**APPLICATION FOR PERMISSION  
UNDER SECTION 16 OF  
THE TOWN PLANNING ORDINANCE  
(CAP.131)**

Proposed Temporary Storage of Construction Materials with Ancillary Office for a Period of 3 Years and Land Filling

**1<sup>st</sup> Further Information**

## Responses-to-Comments

**Annex I - Public Transport Services at Fan Kam Road**

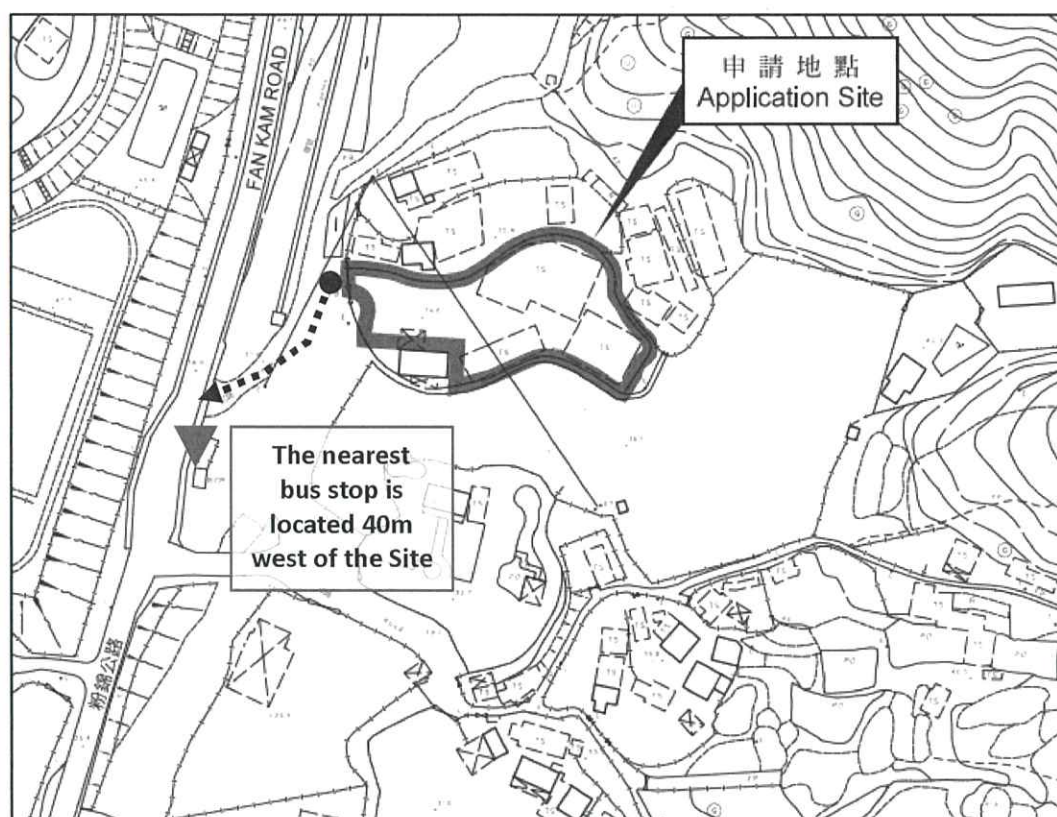
(d)	The applicant should provide nearest public transport services and indicate on the layout plan; and	Plan showing the nearest public transport services is provided for your consideration ( <b>Annex I</b> ).

- (i) The application site (the Site) is located approximately 40m west of Fan Kam Road, which is served with public transport services. Majority of staff is required to commute to the Site by taking public transport to Fan Kam Road then walk to the Site via a local access.
- (ii) The nearest bus stop is located at Fan Kam Road, details are as follows:

**Annex II - Manoeuvring of Vehicles to / from Fan Kam Road and Local Access**

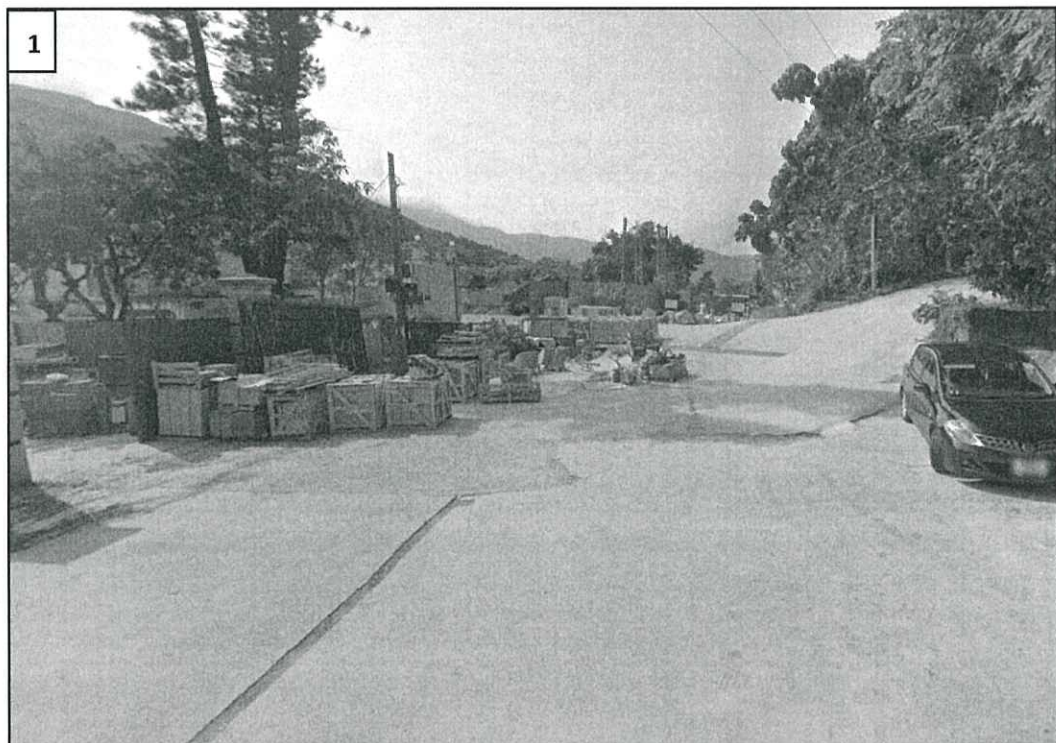
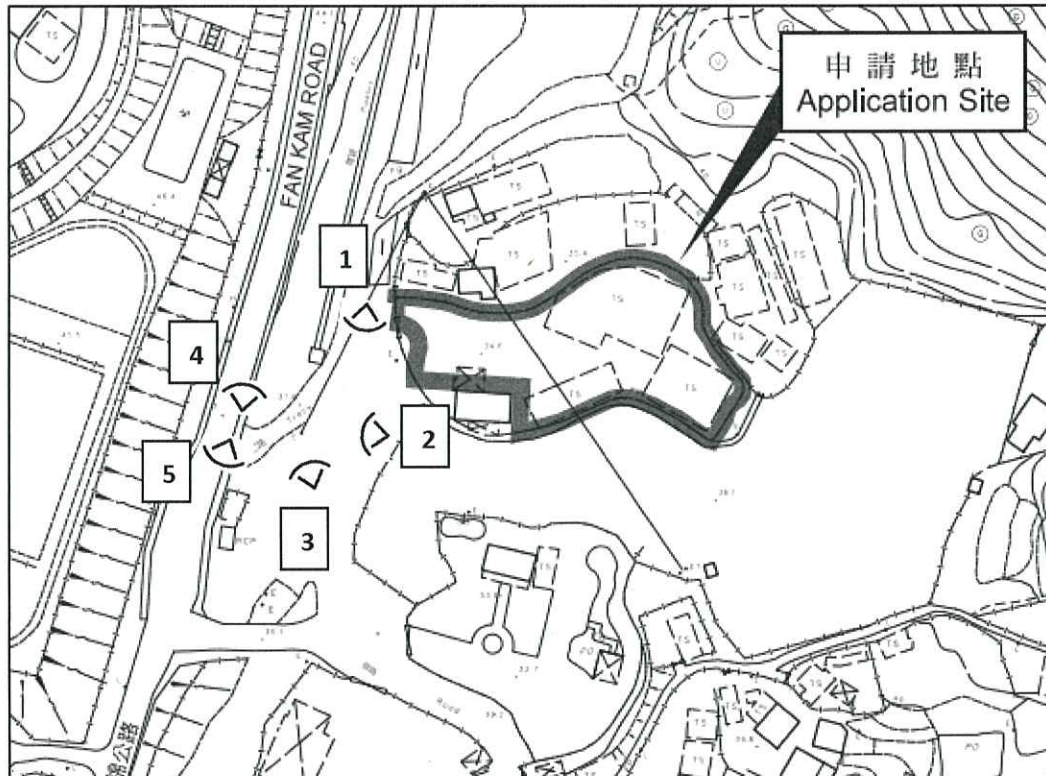
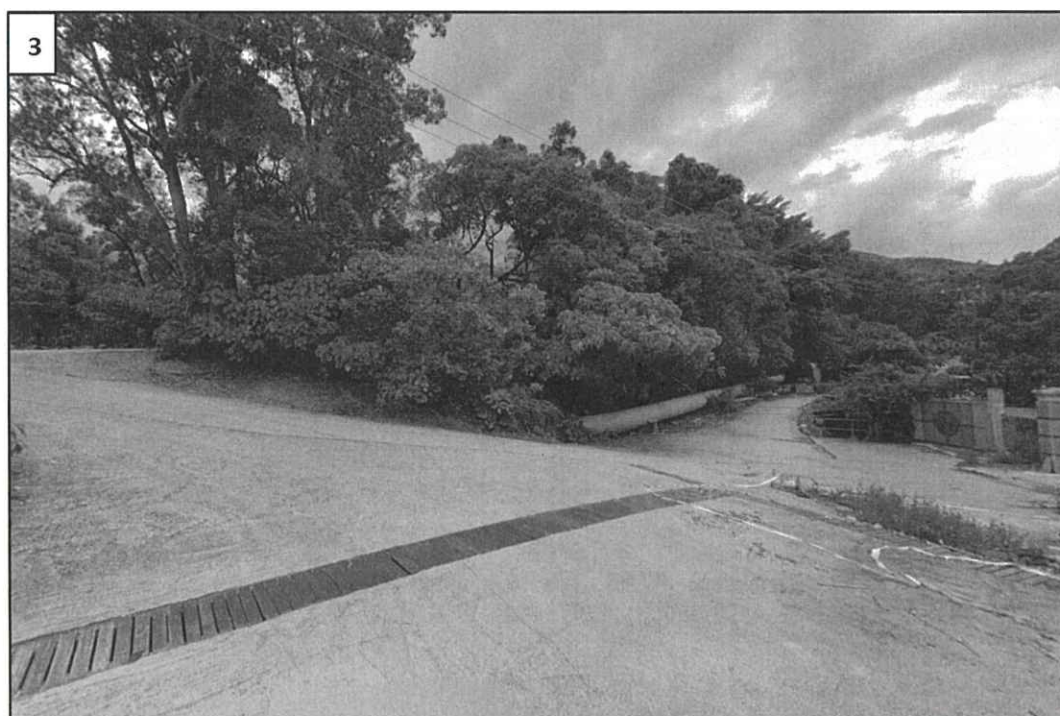
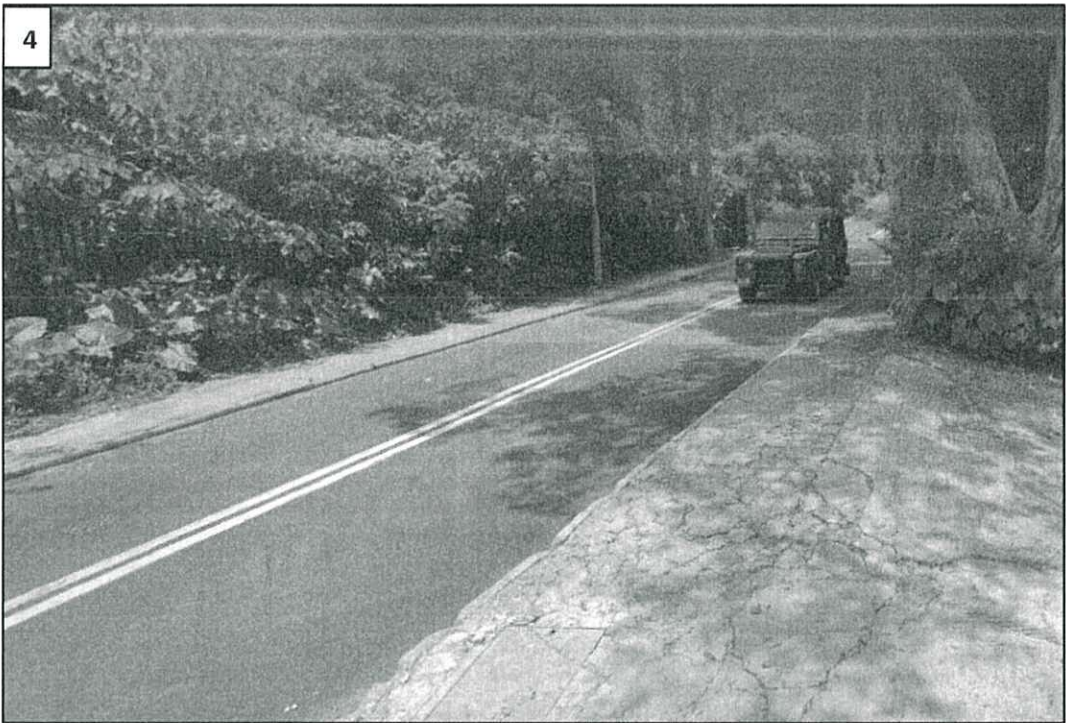
(c)	The applicant should demonstrate the smooth manoeuvring of vehicles to / from Fan Kam Road, along the local access and within the site;	Sufficient space is provided for vehicle to smoothly manoeuvre to / from the Fan Kam Road, along the local access and within the Site ( <b>Annex II and Plans 1 and 2</b> ).

- (i) The application site (the Site) is accessible from Fan Kam Road via a local access (**Plan 1**). Sufficient space is provided for vehicle to smoothly manoeuvre to / from the Fan Kam Road, along the local access and within the Site, details are as follows:
